24th October 2023

Re: Planning Application Ref 2360290 - Permission for Large-Scale Residential Development comprising 267 no. residential units and all associated ancillary / infrastructure works on lands principally located in Bennetstown (townland) to the south of the M3 Parkway park and ride and rail station, and also extending into Pace & Dunboyne (townlands), Dunboyne North, Co. Meath

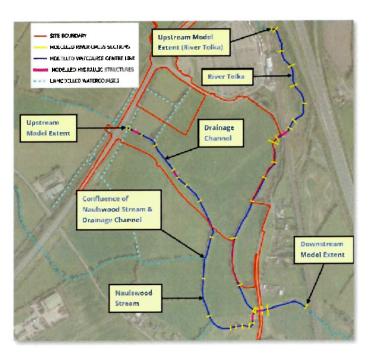
4. Meath County Council Online Strategic Flood Risk Assessment mapping portal clearly shows that a number

of our existing houses East of the Tolka are already within Strategic Flood Zone B (those properties outlined in green opposite). This mapping was produced as part of the 2021-2027 Meath Strategic Flood Risk Assessment (SFRA) and does not account for waters from a local drainage channel and Naulswood Stream both of which hugely contribute to flood risk in this area. It is also important to note that this mapping (completed in 2019) cannot have taken account of the additional surface water which will be diverted to the Tolka as a result of the proposed development nor the further commercial development which this application directly facilitates. The purpose of the Site Specific Flood Risk Assessment included as part of the

application is to demonstrate that the applicants have accounted for flood risk as part of their new scheme design and have kept proposed housing units away from areas destined to flood. What it does not consider is what we believe to be an inevitable increased risk of flooding to the existing houses in the locale as a direct result of the introduction of huge additional volumes of surface water which will emanate from the subject site during periods of heavy rain.
